Re: CL2023-41 - Orono Arena and Community Centre - Indoor Rink Refurbishment

Addendum Number 2

CL2023-41 **Orono Arena and Community Centre - Indoor Rink Refurbishment**
Addendum #2

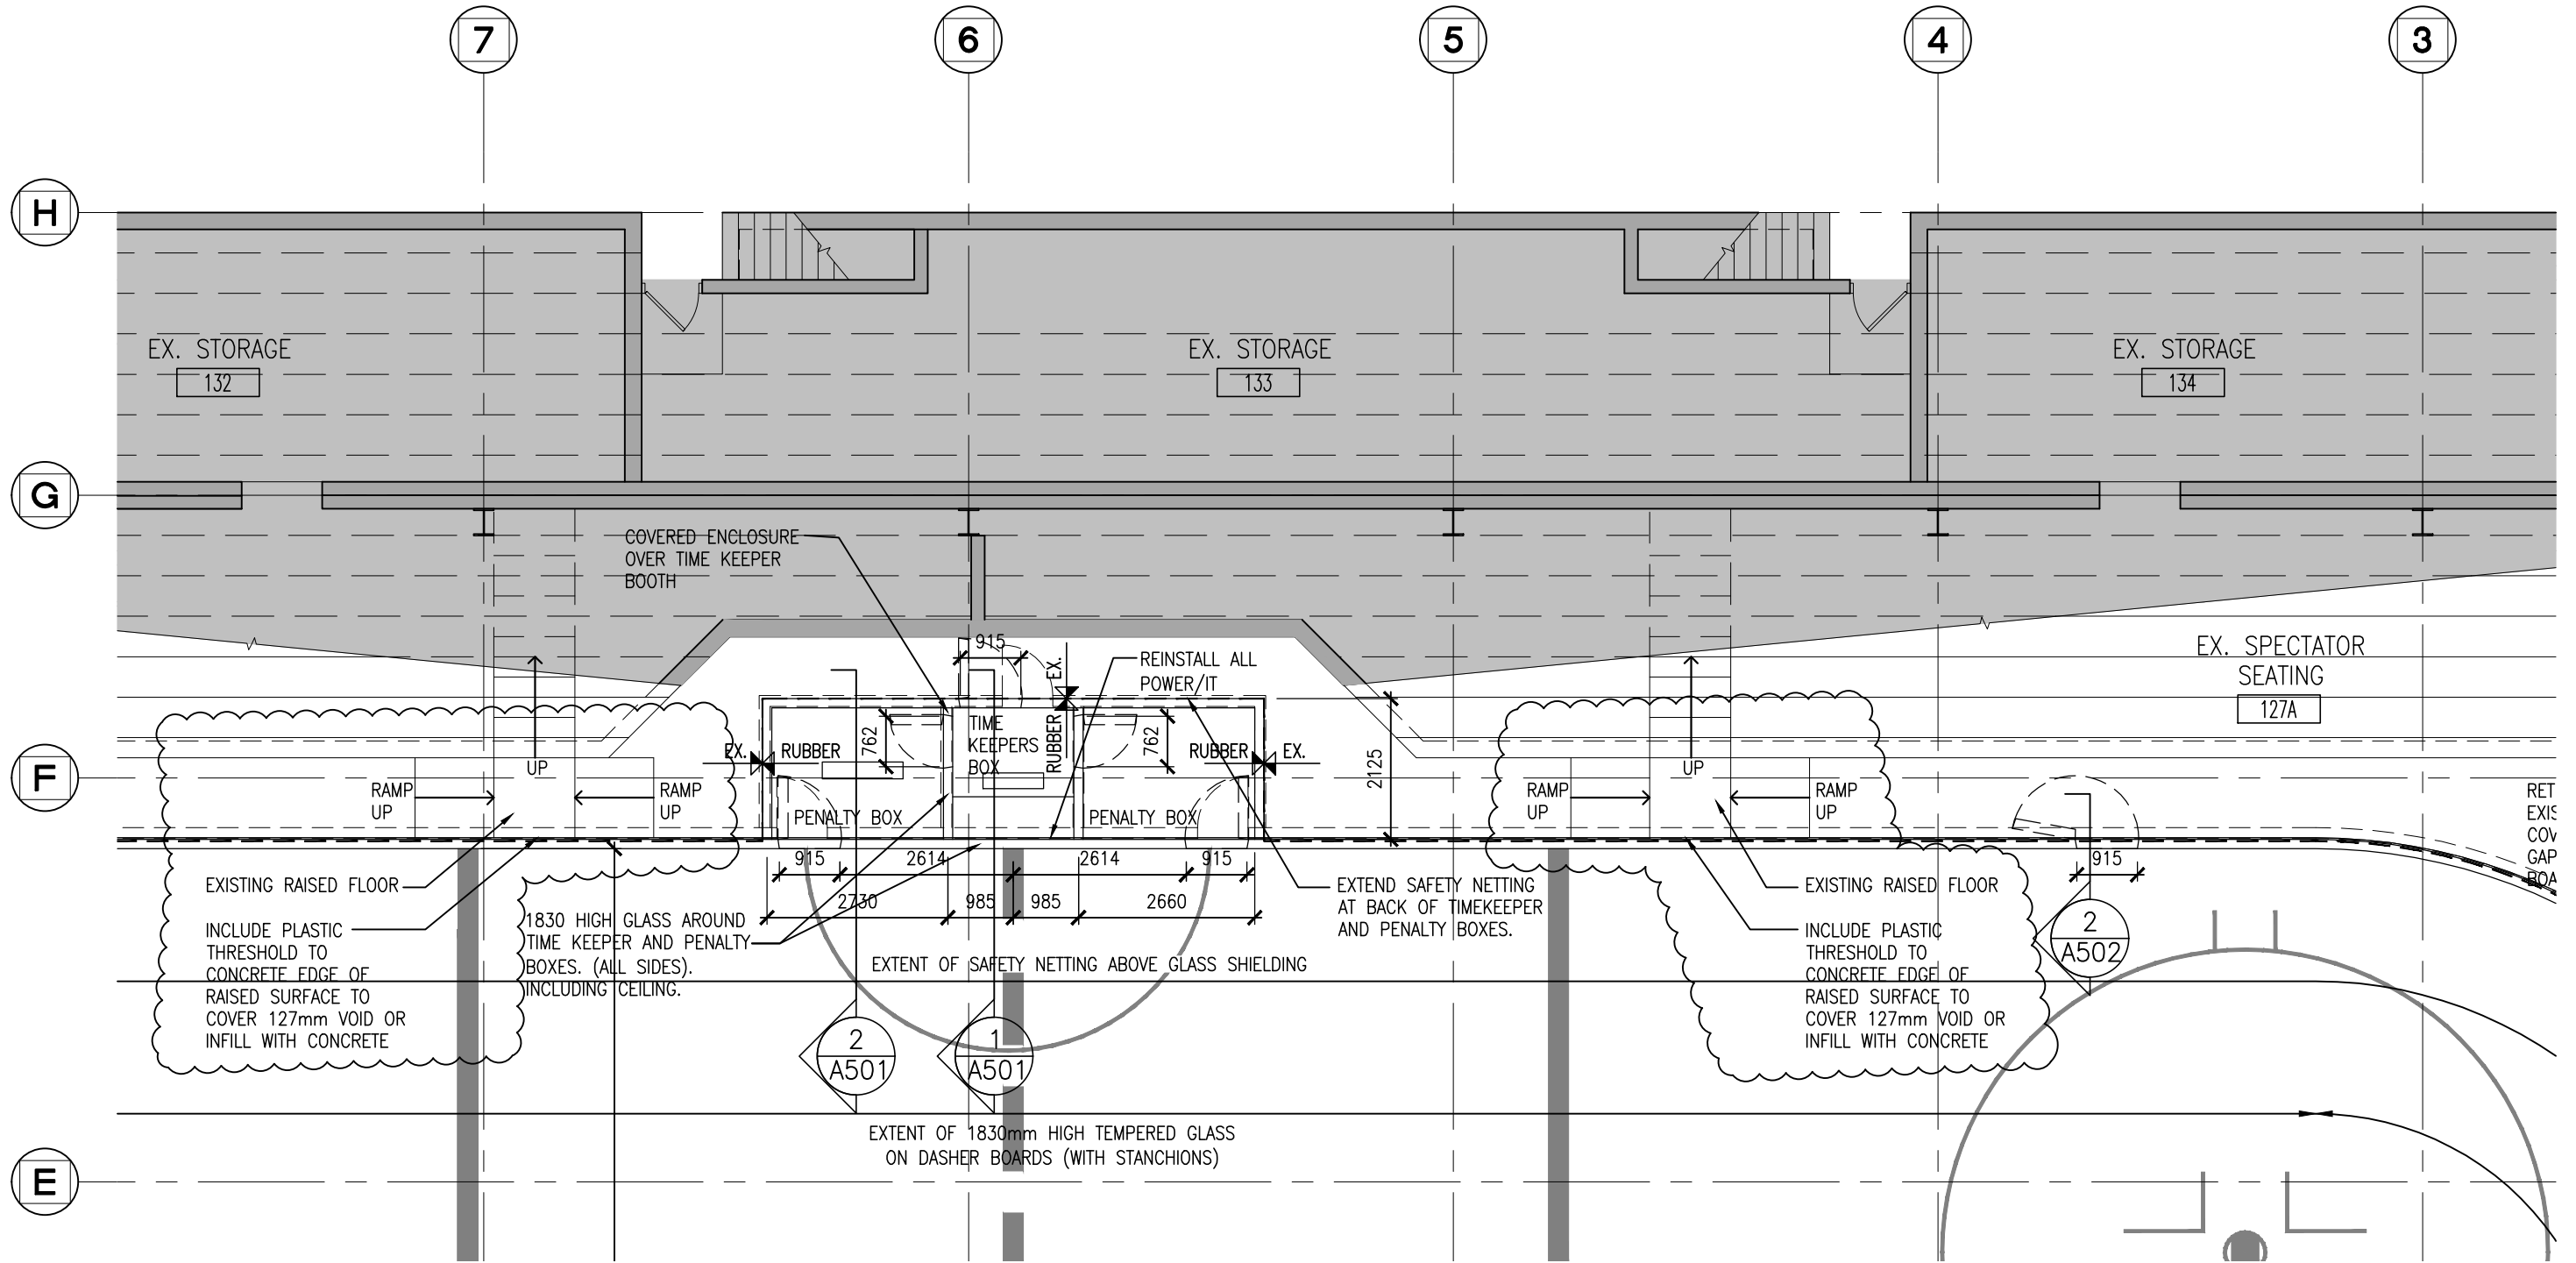
8. There are two (2) sloped concrete ramps at the stairs to the viewing area in the rink. These ramps must remain, the void between the new dashboards (located on the rink) and the existing concrete ramp must be sealed with a HDPE from the dashboard to edge of concrete or infilled with concrete to match the existing ramp profile and provide closure. Refer to Barry Bryan Associates SKA-01 for additional information.

**REVISED SECTION @
VIEWING AREA**

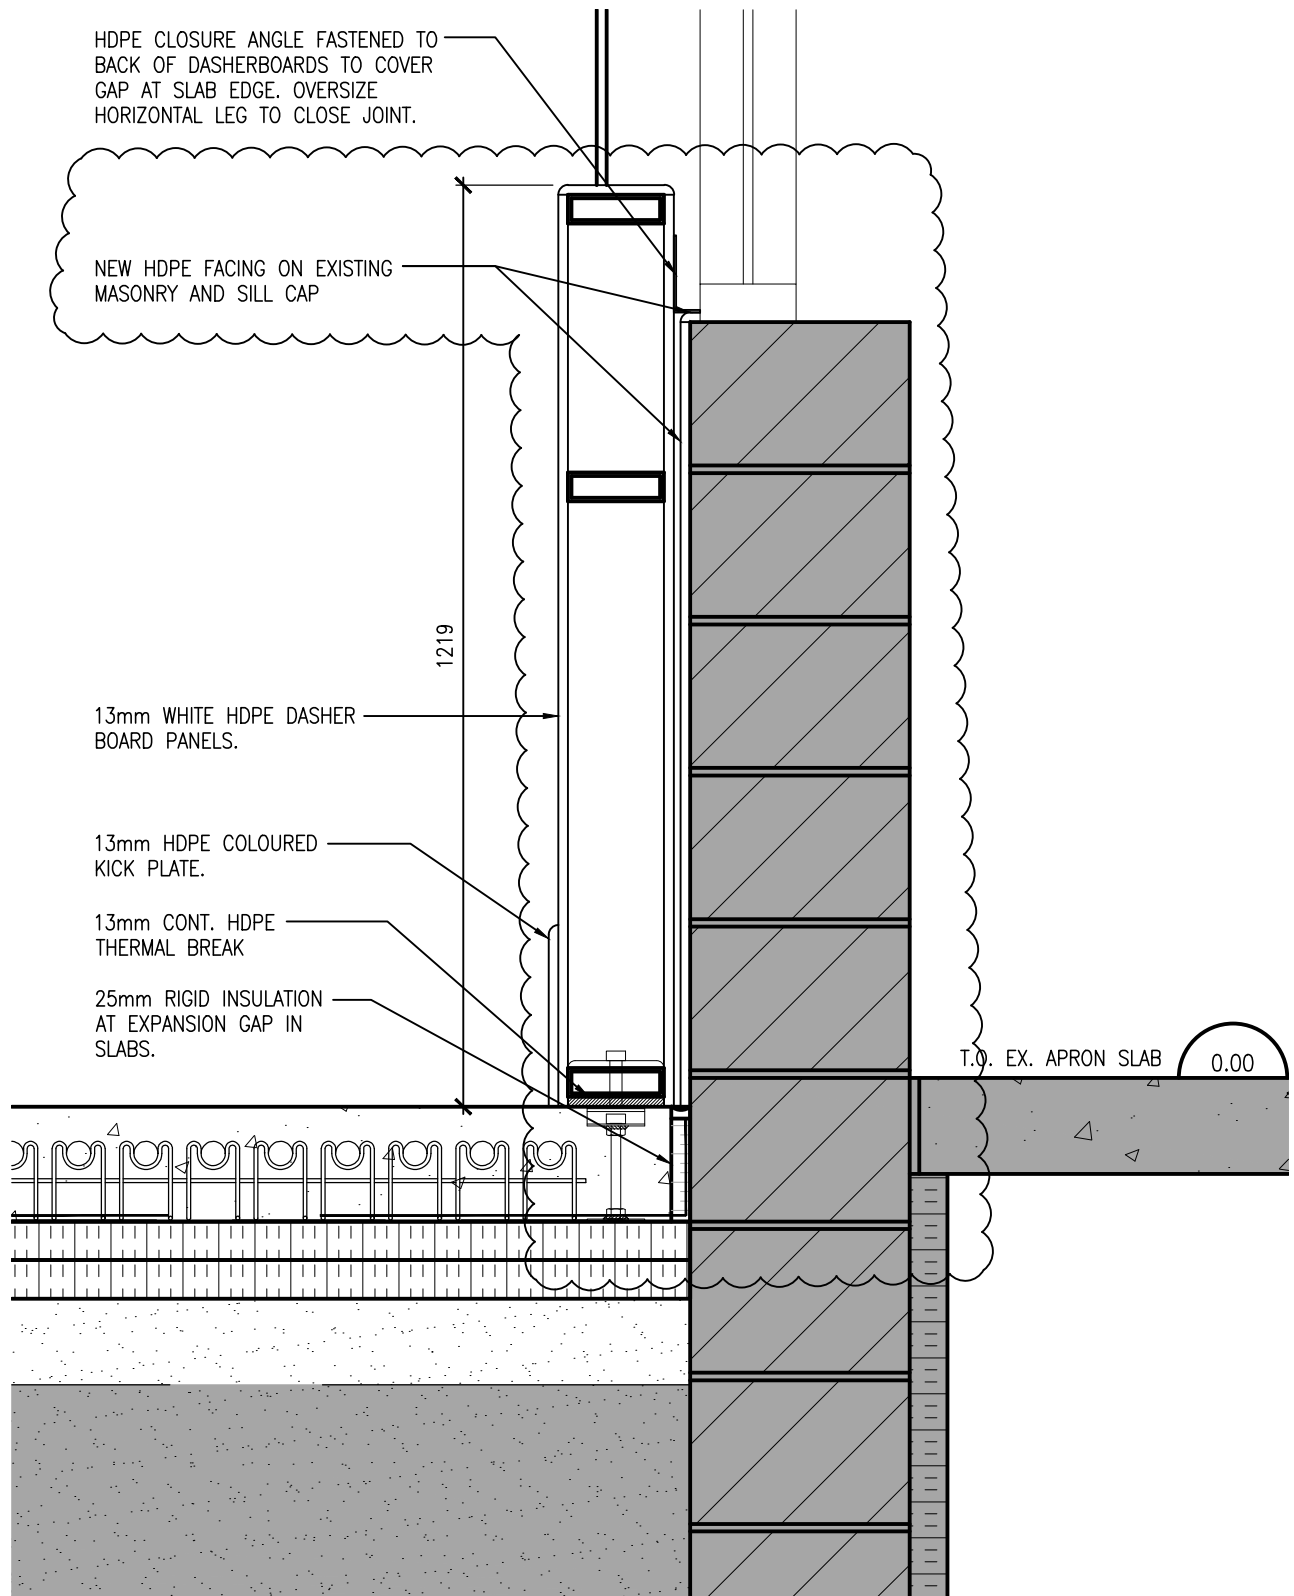
Backer panel is required around the entire perimeter of the new dasher boards. Additionally, the lobby wall which is currently acting as the dasher boards at the south end of the rink shall be re-faced with new plastic laminate puck board and top closure see attached sketch SKA-02.
